**ADDENDUM TO
WEST DON LANDS
CLASS ENVIRONMENTAL
ASSESSMENT MASTER PLAN
FOR STORMWATER QUALITY**

**City of Toronto
Waterfront Toronto**

FINAL REPORT

RVA 071345

STORM DRAINAGE AREAS

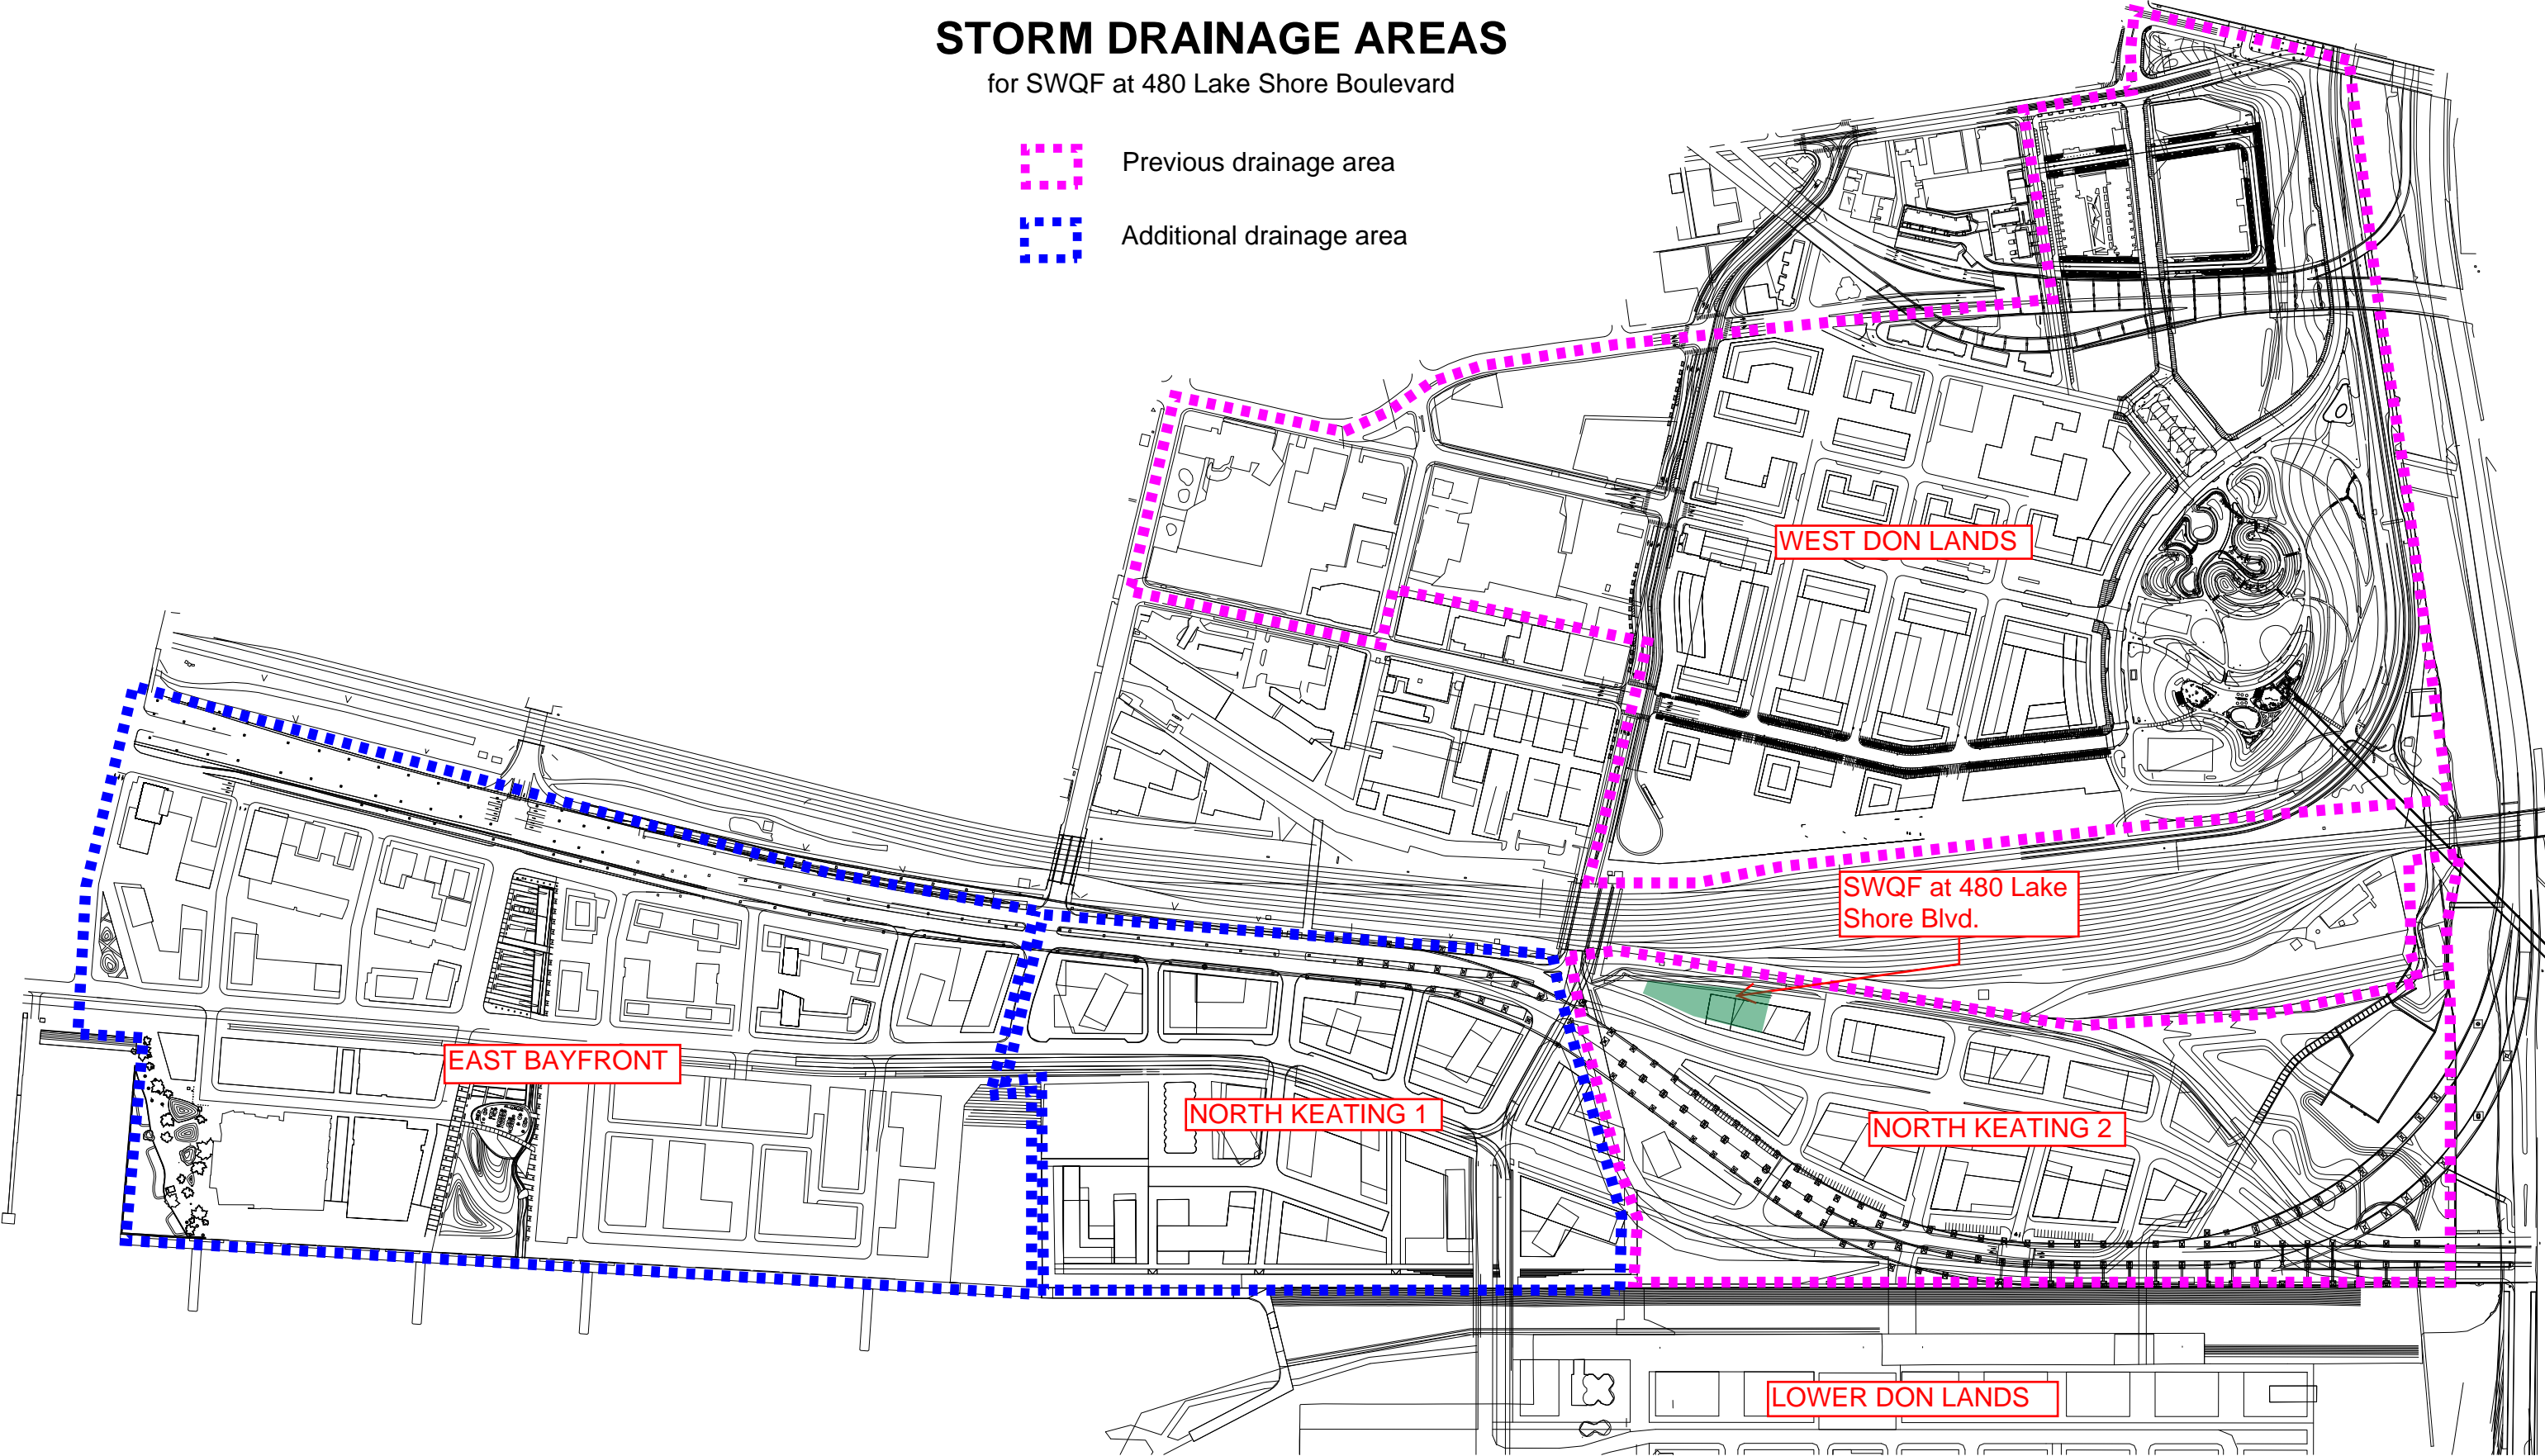
- Please advise on figure 15-15 since the label reads Lower Don Lands
- On the storm drainage areas, you may want to include a note that reads that the highlighted streets and blocks are as per the Keating Channel Precinct Plan

OPTIONS FOR STORMWATER TANK LOCATIONS

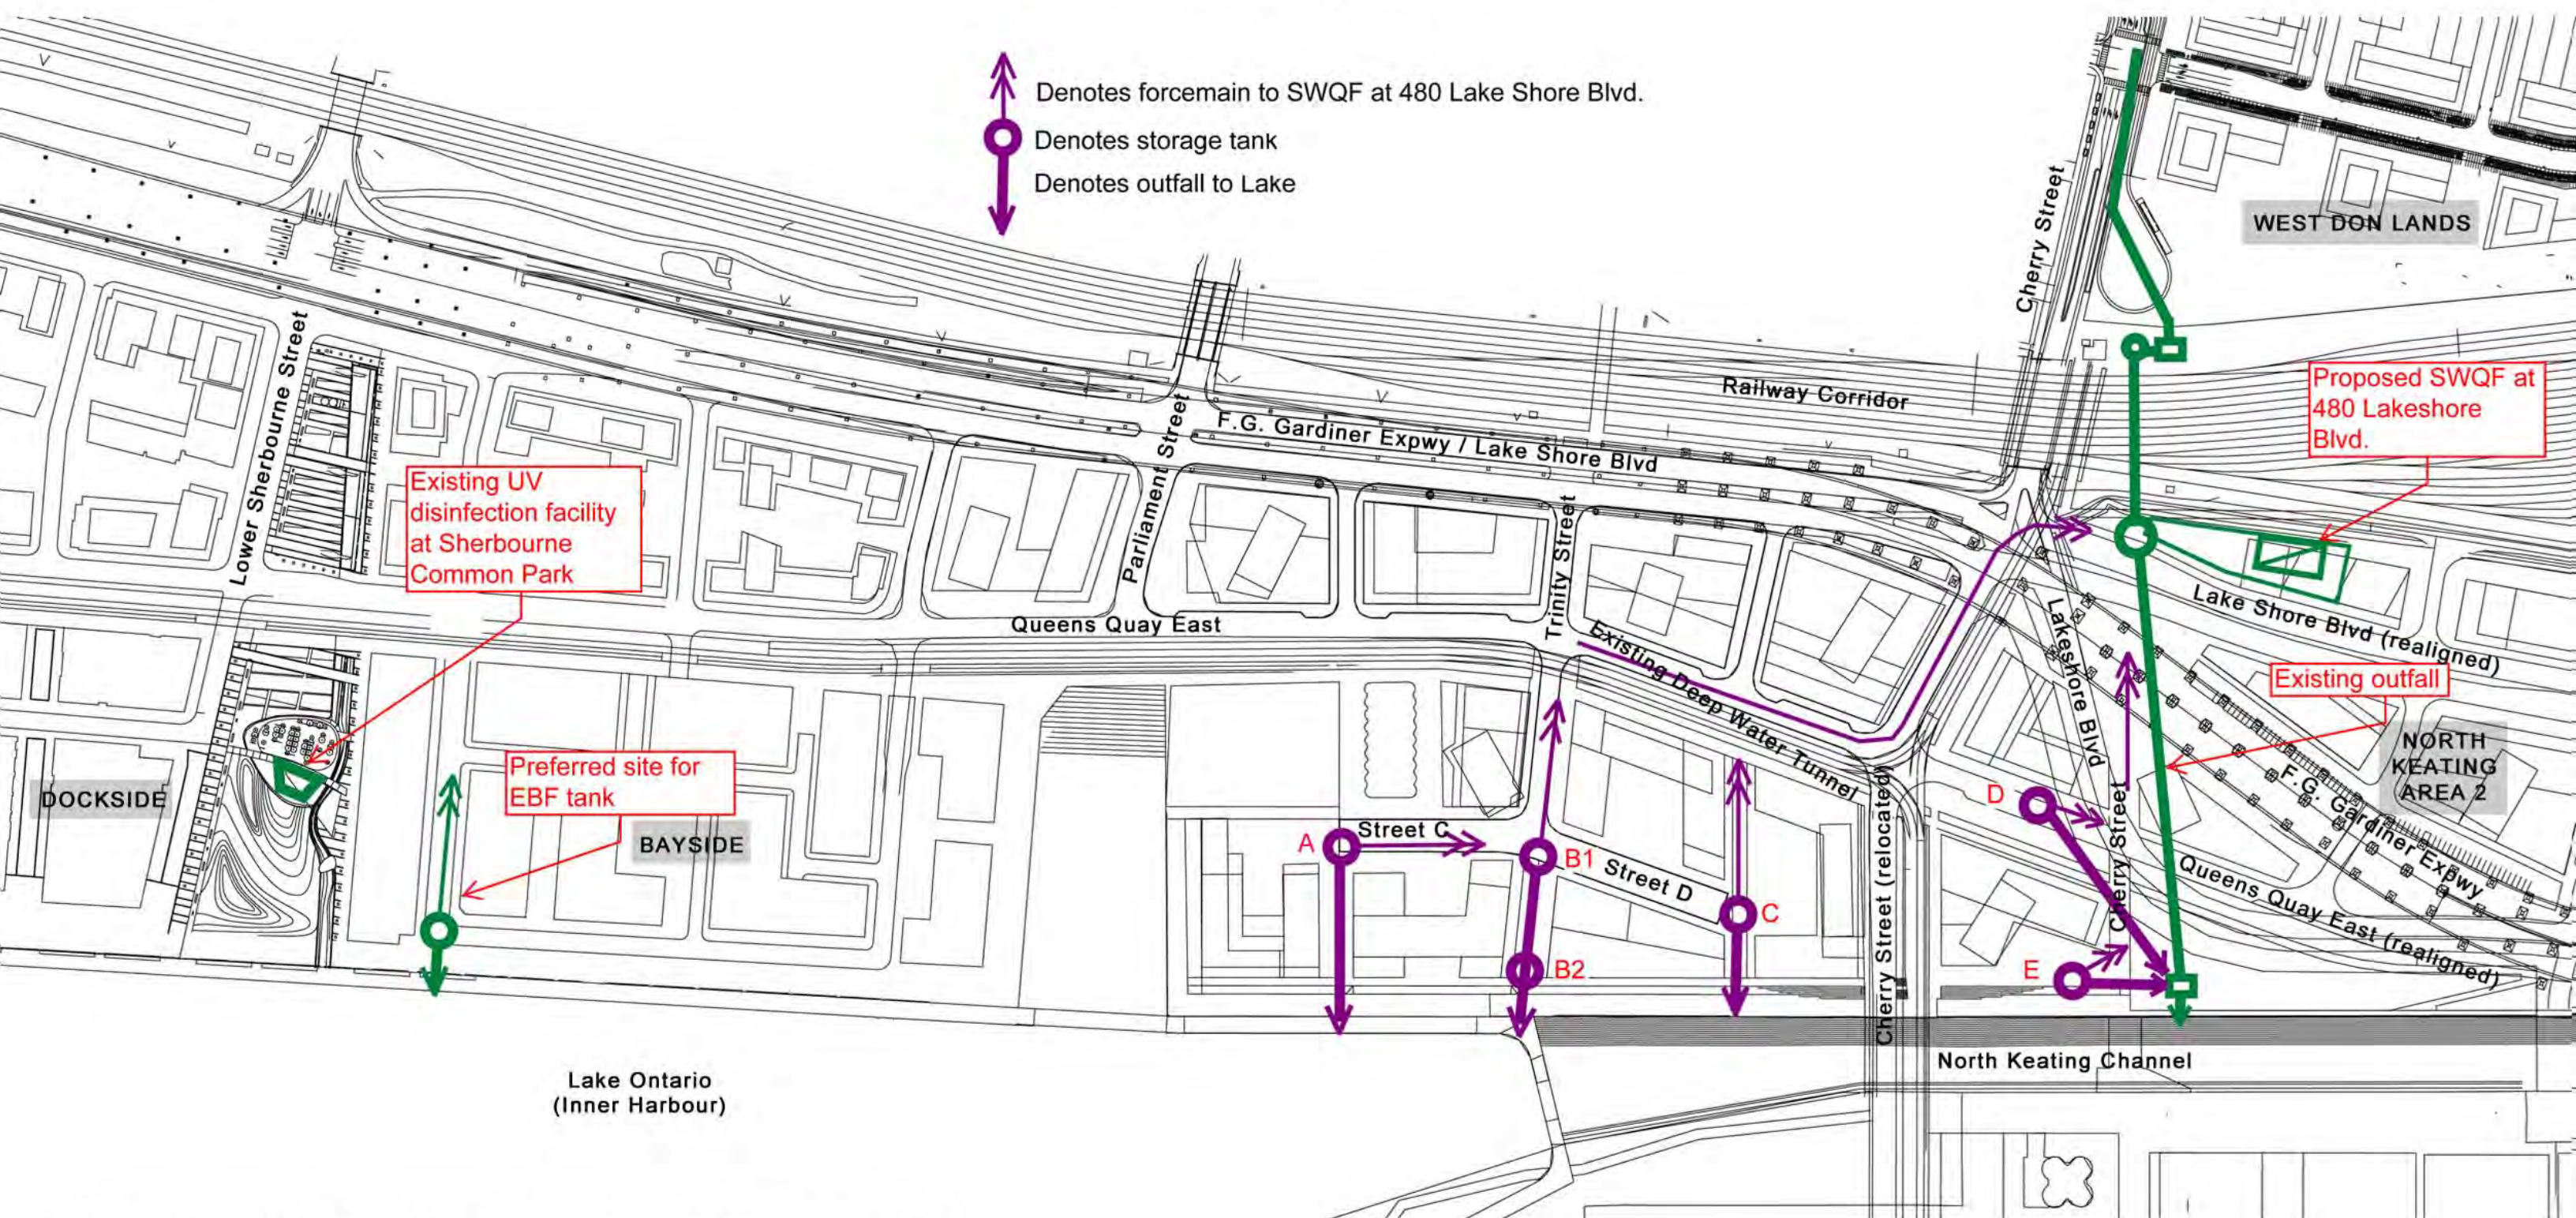
- Please append the various handouts referenced in meeting minutes i.e. March 14, 2013 handouts
- Point 2- please note that it is our understanding that the CSO within the existing Cherry Street ROW will stay at its current location. The CSO does not cross the NK1 lands. That said, the deep water tunnel does cross the NK1 lands (please see attached survey and reference plans for 3C, silo and Bunge site for its location).

- Point 5- please note that the Keating Channel Precinct Plan was endorsed by City Council and Zoning Bylaw No. 1174-2010 was adopted by City Council. The 3C lands is seeking a revised road pattern from what was outlined in the Keating Channel Precinct Plan but is maintaining the public ROWs outlined in the Zoning Bylaw, which is currently under appeal at the OMB.

- Please move Point 10 to Point 5 (with existing text) or a new Point 6
- Point 13- please clarify that RVA will circulate revised materials prior to filing addendum

- The location of the deep water tunnel is not correct. Please refer to the attached plans.

8. It was agreed that Options A and B are generally OK. However, Option B will be evaluated as two sub-options B1 and B2 with the flexibility of moving the tank location to the south (closer to the Lake) if the road pattern is changed. Refer to the revised Options for Stormwater Storage Tanks Locations dated May 21, 2013 (attached). RVA

10. It was agreed that Option C is generally not acceptable since it is not compatible with the proposed development road layout (A. Romano indicated that the road pattern is proposed to be revised showing no municipal road that this location). Option C would only be possible if the road pattern is not changed

11. Option D would be revised to show storage tank between old Cherry Street and new Cherry Street (refer to the attached revised Options for Stormwater Storage Tanks Locations dated May 21, 2013). Option D will be evaluated as two sub-options D1 and D2. It is noted that Queen's Quay LRT could be extended east of new Cherry Street which could impact the feasibility of this location. It is also noted that the pending EA for the Gardiner Expressway could result in re-alignment of road pattern east of new Cherry Street (decision expected March 2014).

STORM DRAINAGE AREAS

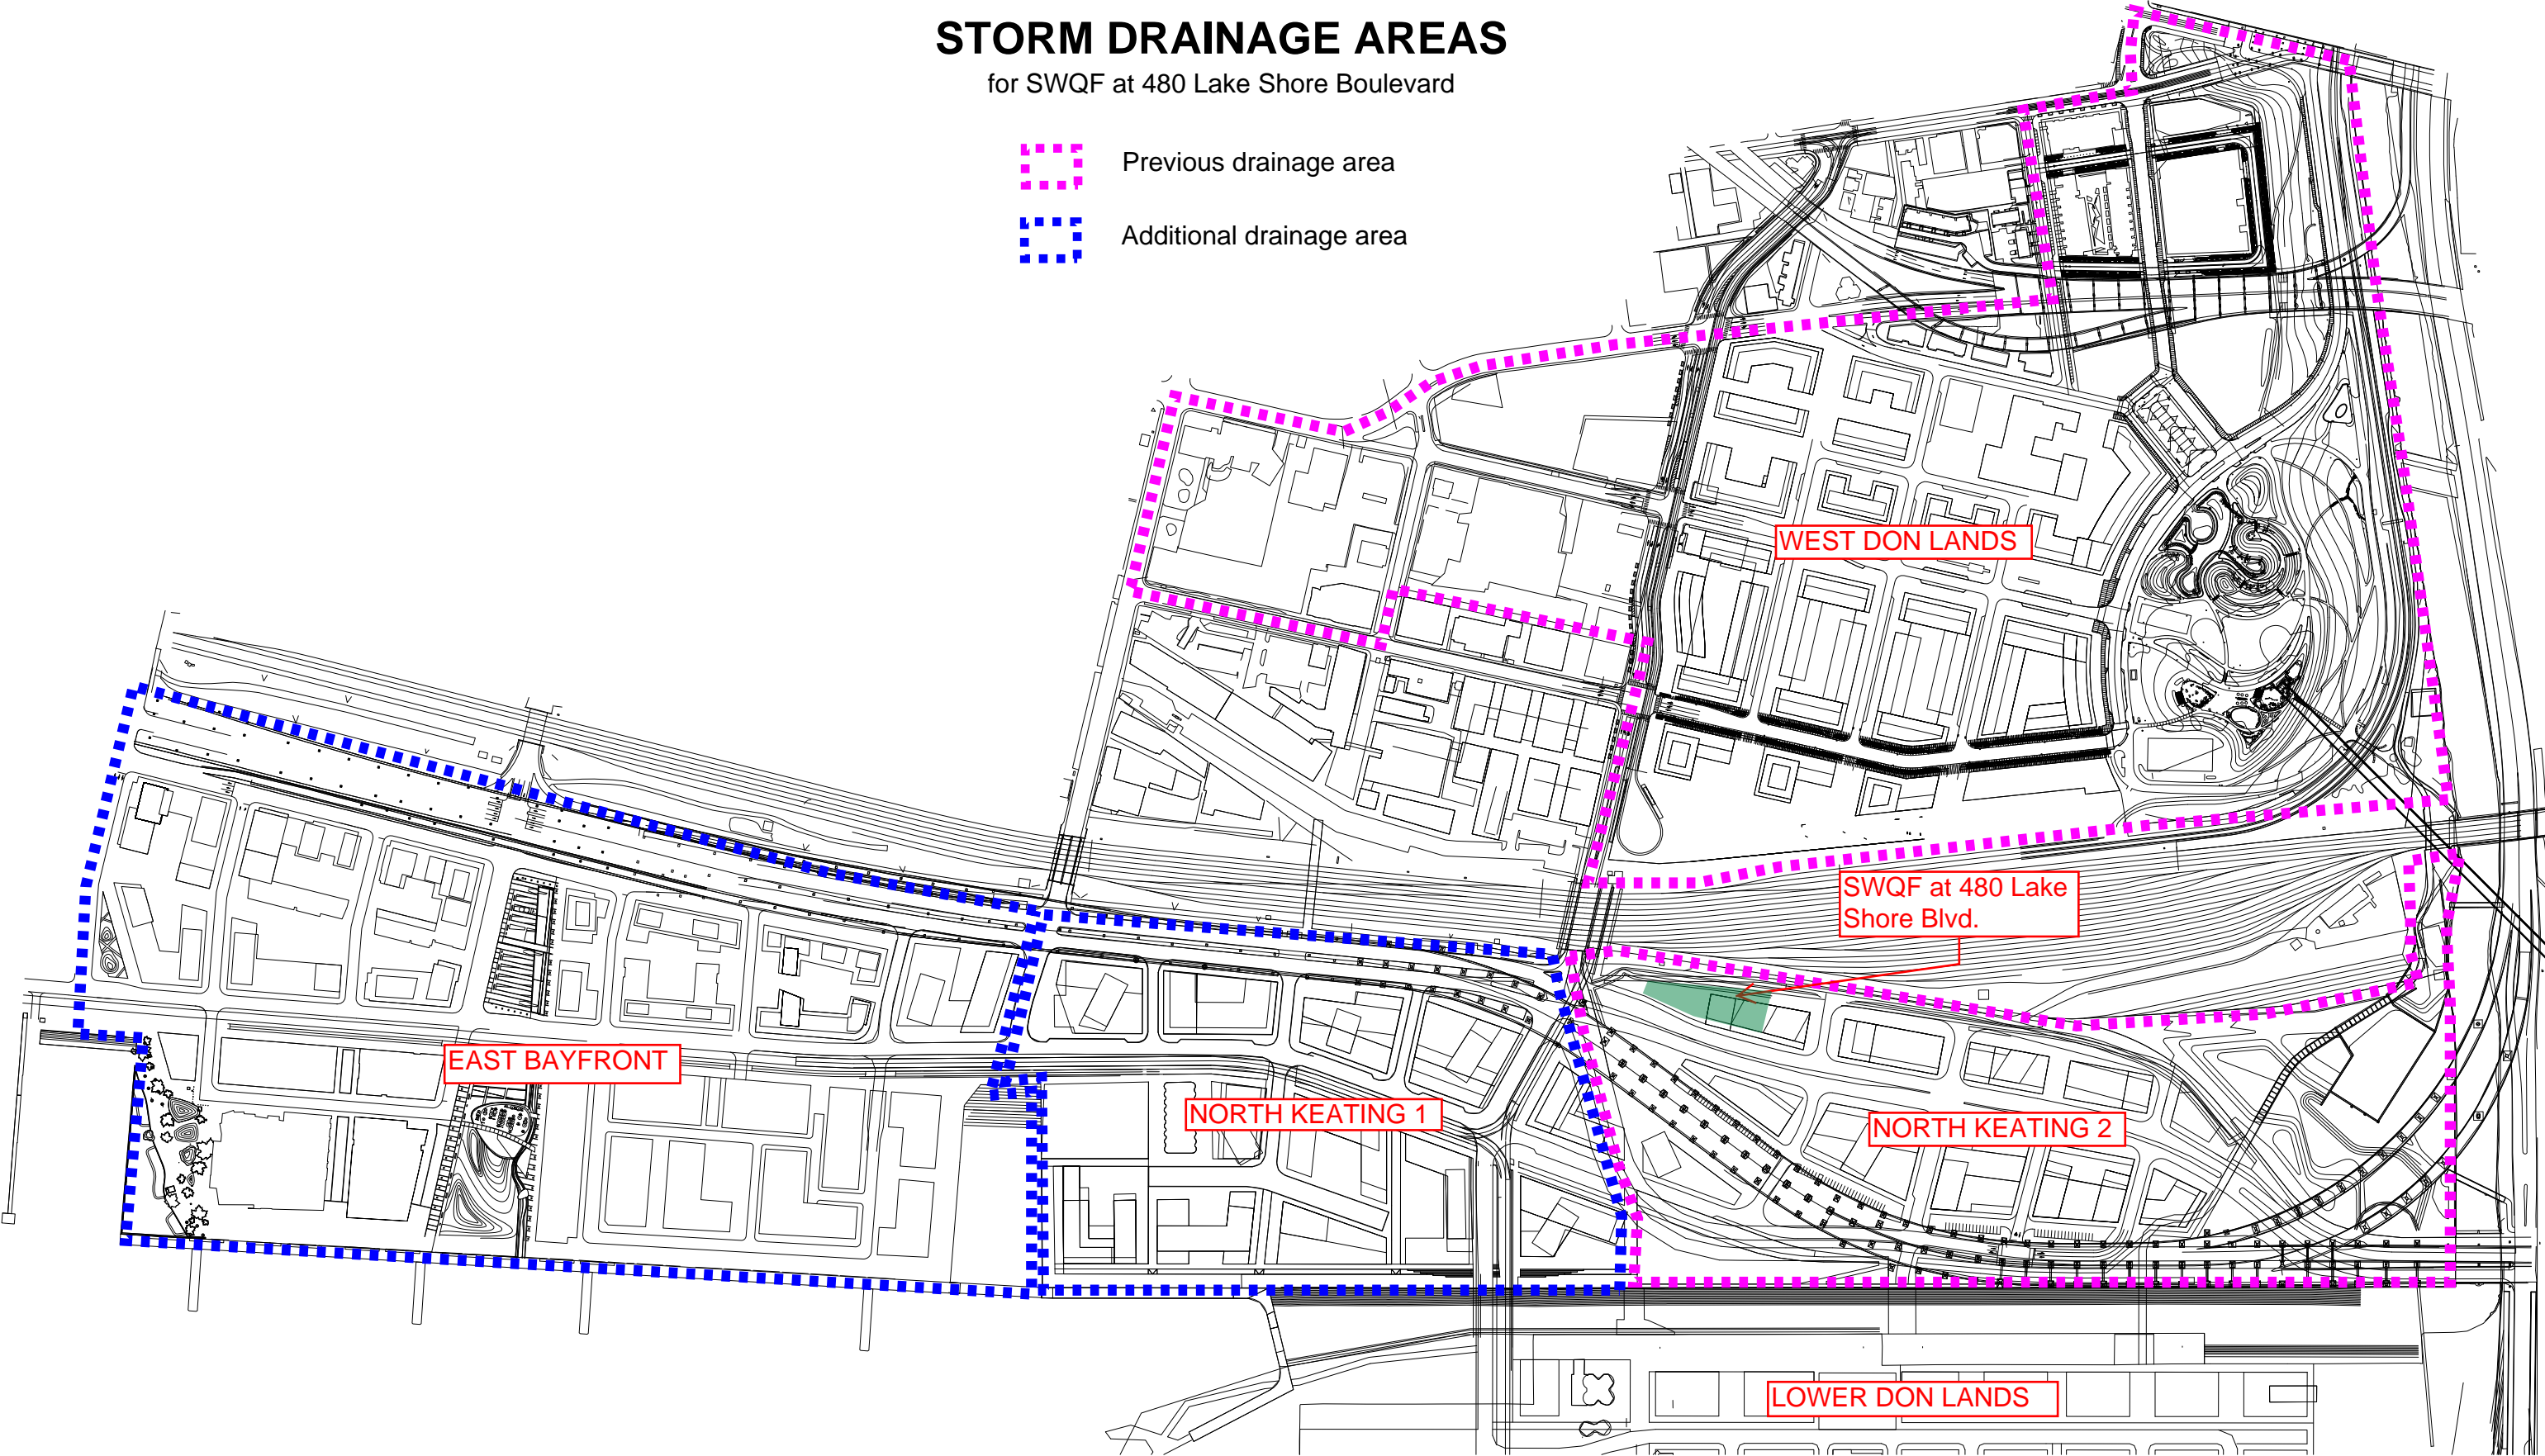
- * Please advise on figure 15-15 since the label reads Lower Don Lands
- * On the storm drainage areas, you may want to include a note that reads that the highlighted streets and blocks are as per the Keating Channel Precinct Plan
